Re: 5th Submission Review – Lona / Forum Vista Creek – Master Plan, Site Plan and Final Plat
Application Number: **DA-2248-01**
Case Numbers: **2021-7009-00; 2021-4025-00; 2021-3051-00**

Fourth Submission Review

T R A F F I C I M P A C T S T U D Y

Turn Lane Queuing Analysis Results

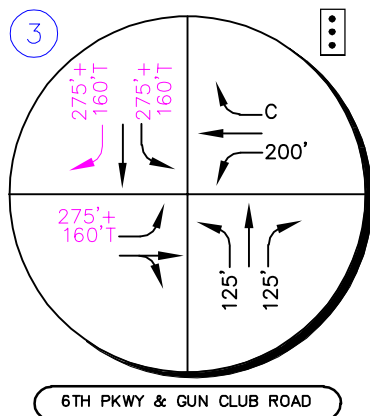
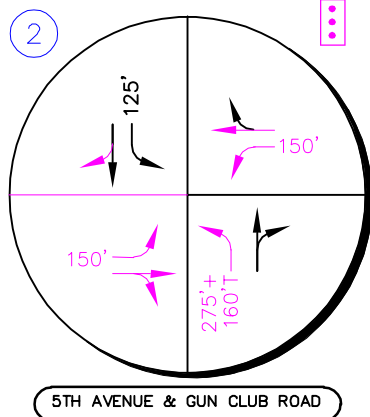
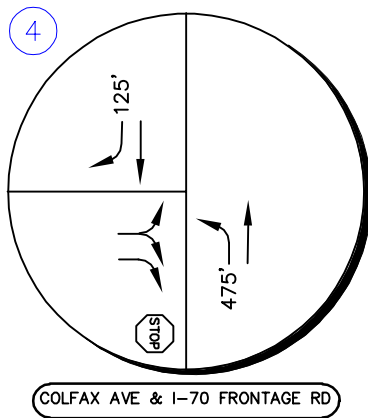
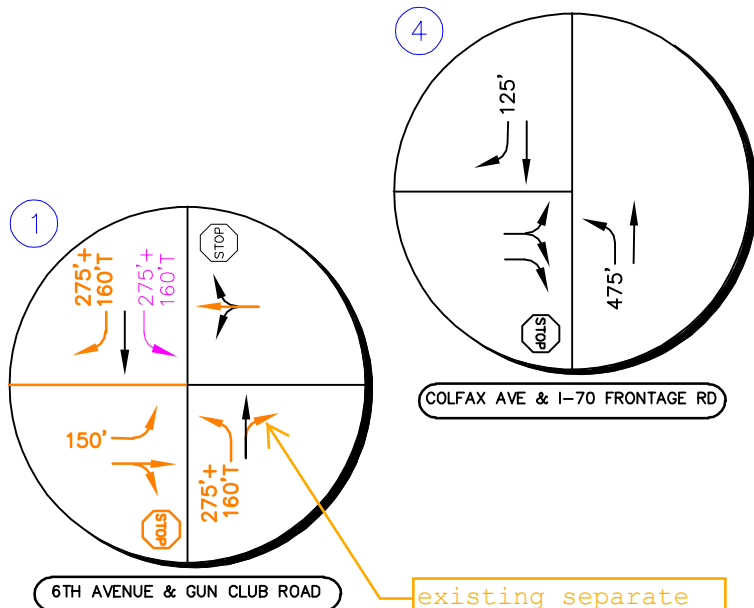
keep existing
separate NB right
turn lane, update
analyses

Note that storage lengths may
be reduced to meet calculated
queue lengths with a minimum
storage length of 50'.

The revised study was updated with a northbound right turn lane at the intersection of 6th Avenue and Gun Club Road.

FIGURE 13

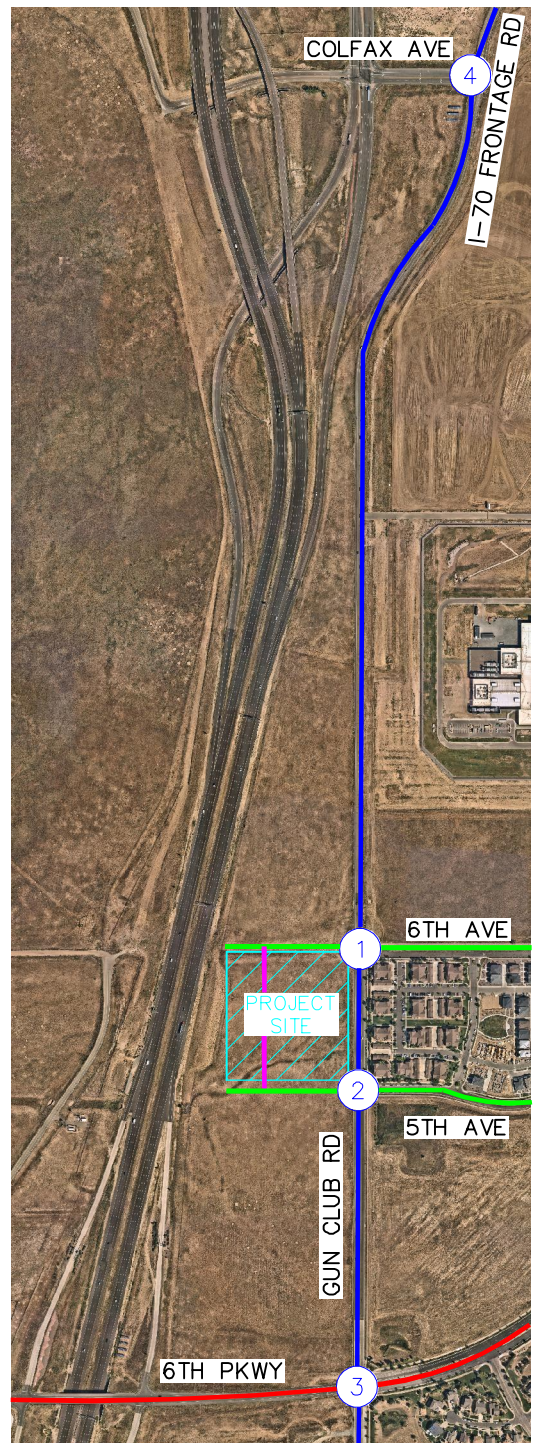
need to maintain existing separate NB right turn lane, update analyses
- It is anticipated that the proposed adjacent development to the south, Lamar Landing Subdivision, will be constructed and will construct the west leg and a northbound left turn lane at the intersection of 6th Avenue and Gun Club Road. The intersection of 5th Avenue and Gun Club Road is anticipated to meet four-hour vehicular volume warrants in 2024; therefore, signalization is anticipated to be the appropriate control at this intersection by 2024. If signalized, the eastbound and westbound approaches of this intersection should provide 150-foot designated left turn lanes and a shared through/right turn lane. It should be noted that signalization is triggered by traffic volumes on the east leg of this intersection;

The revised study was updated with a northbound right turn lane at the intersection of 6th Avenue and Gun Club Road.
